PLANNING CONSULTATION BY LONDON BOROUGH OF TOWER HAMLETS

ORCHARD WHARF, ORCHARD PLACE, POPLAR, LONDON, E14 0JY.

SUMMARY

Appendix C Extract from Design and Access Statement.

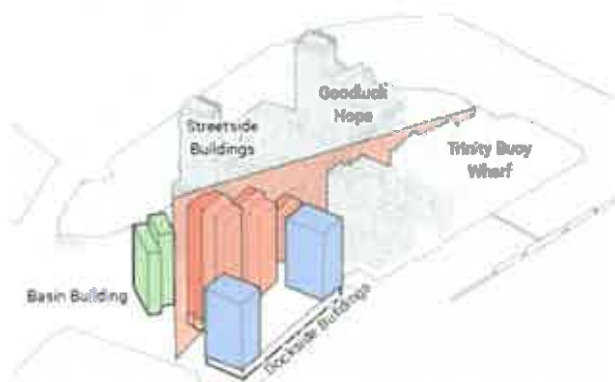
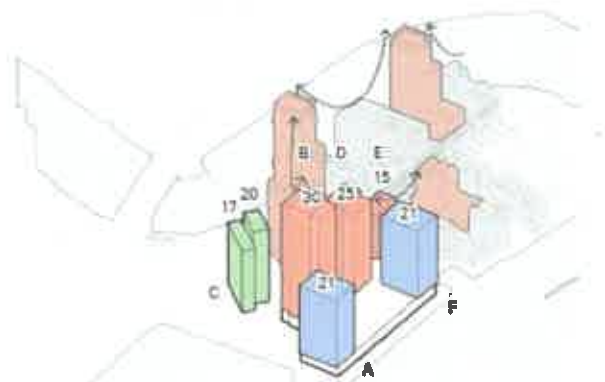
- a) the height, mass and combined design treatment of blocks A, B and C and the proposal to lower the development alongside the Basin thereby reducing the impact of the residential blocks on the open, waterside character of the Basin;

- b) the need for a greater set back between Block A and the boundary of East India Dock Basin both to provide additional landscaping/buffer planting and to safeguard bird flight paths;

- c) the provision of additional planting and landscaping alongside the boundary with the Basin in front of Block B linking with and strengthening the proposed public realm area around Block C;
